Date: April 22, 2021
Subject Property Address: 465 Anglers Drive
PIN: 164900001
Permit Number: TB-21-338
Permit Applicant Name: Ed Becker

This Permit Application is being reviewed under the 2018 ICC Adopted Codes, and the State Adopted 2020 NEC.

Interior alteration for
Advocates of Routt County
Sundance Plaza
465 Anglers Dr. - Unit 1-E
Steamboat Springs, Colorado

1 FLOOR PLAN
SCALE: 1/4" = 1'-0"

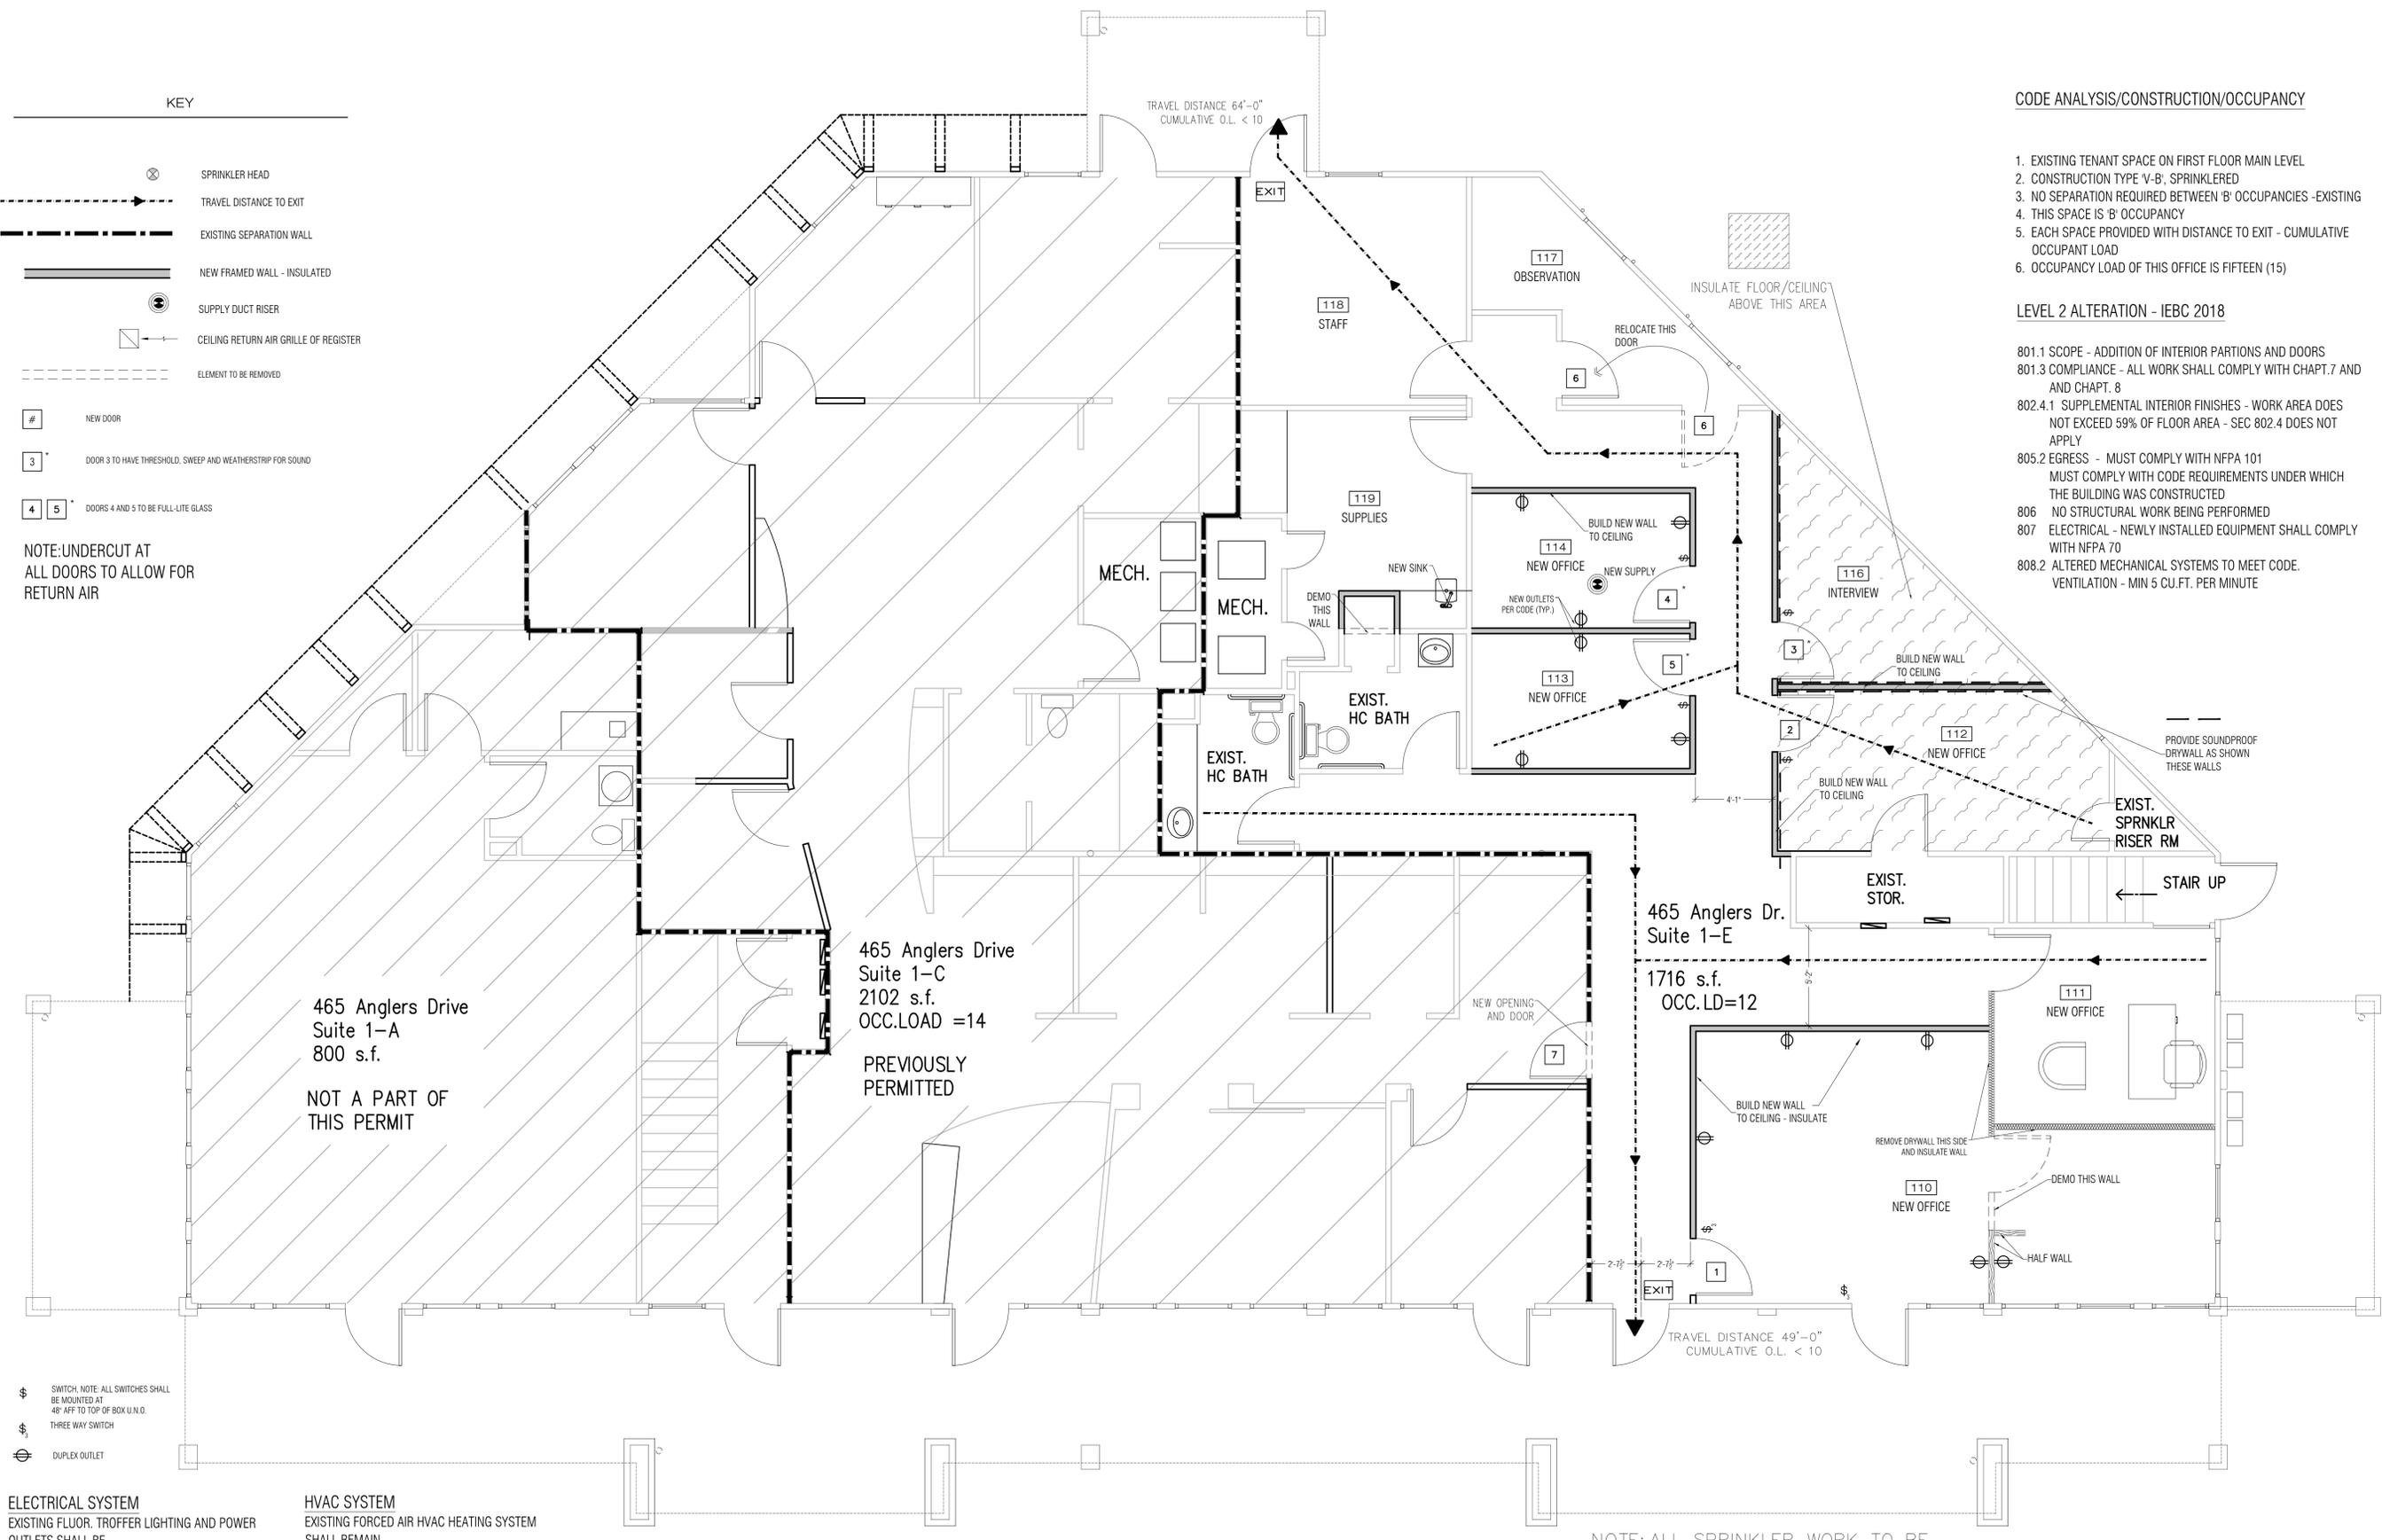
Conditionally Approved – pending deferred submittal of Fire Alarm/Sprinkler plan/permits by sub-contractor to Fire Prevention. See www.steamboatsprings.net, Fire and EMS Services, Fire Prevention, Downloadable Permits and Forms.
